PROPOSED AMENDMENT TO PLANNING APP 2A/1011/0718 BARN CONVERSION CHERRY TREE BARN, HALGATTON LANE.
LL13 0SCW

ADDITION OF PORCH TO CURRENT PLANS. CURRENT

P12009/1051
POST-
DECISION

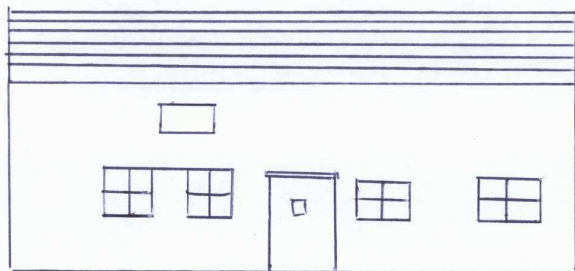
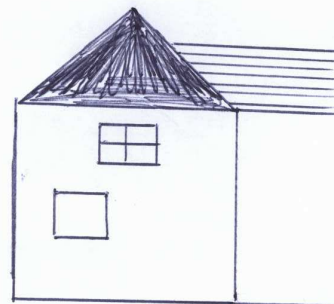
PROPOSAL IS FOR TIMBER/BULK/SLATE PORCH SYMMETRIC TO CURRENT CONVERSION

ADDITION OF PORCH TO CURRENT LANE. PROPOSED

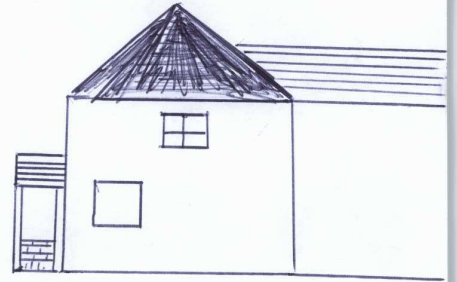
DIMENSIONS

W = 1900

H. = 2000 (TO APEX 2600).

D = 1000

PORCH WILL BE BRICK TO 600mm - THEN OPEN SIDES.

TIMBER CONSTRUCTION - SLATE ROOF. (BRICK + SLATE TO MATCH CURRENT BUILDING)
